Socket Size Irregularity

This Technical Bulletin affects the following Reliance products :

- 3022-17 Socket
- 3022-2 Remote Pole with Socket

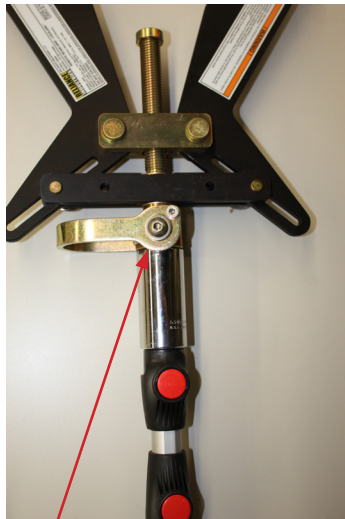
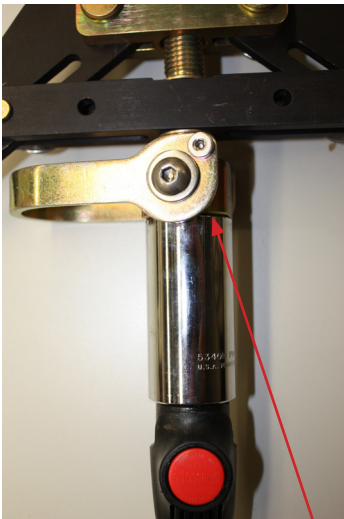
Issue : The 3022-17 socket Original Equipment Manufacturer (OEM) recently made a change to the interior dimensions of the 3022-17 socket. The result of this change is that the new socket well is not deep enough to properly engage the ball-detent with the corresponding notched grooves inside the socket.

Photos below demonstrate both the correct and incorrect placement of the socket, and clearly illustrate the change to the interior portion of the socket.

A properly seated socket is flush against clamp.

Improperly seated socket is not flush against clamp.

The correct socket should have two sets of notches on each of the socket walls, and should seat flush against the clamp. If you are in possession of a socket that does not fit properly, or has only one set of notches in the socket walls, please contact Reliance for further instructions.

Correct (Left) & Incorrect (Right)

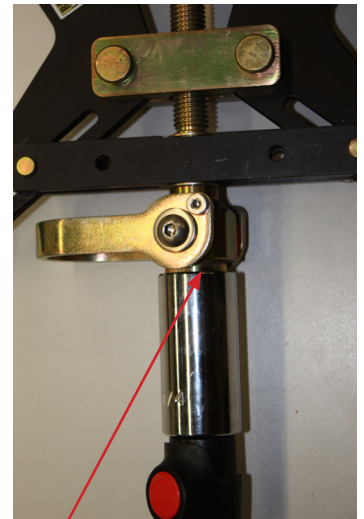
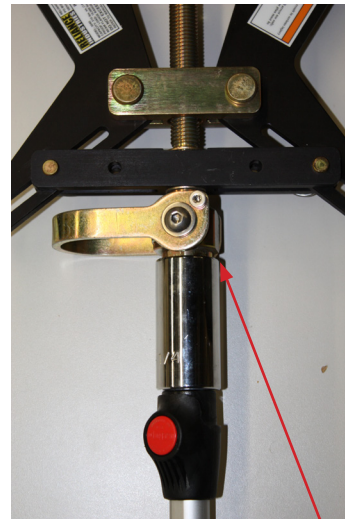
Wall of socket at bottom is thinner in the correct version of the socket. The wall thickness in the incorrect version is not deep enough to properly engage the ball-detent with the corresponding notched grooves inside the socket.
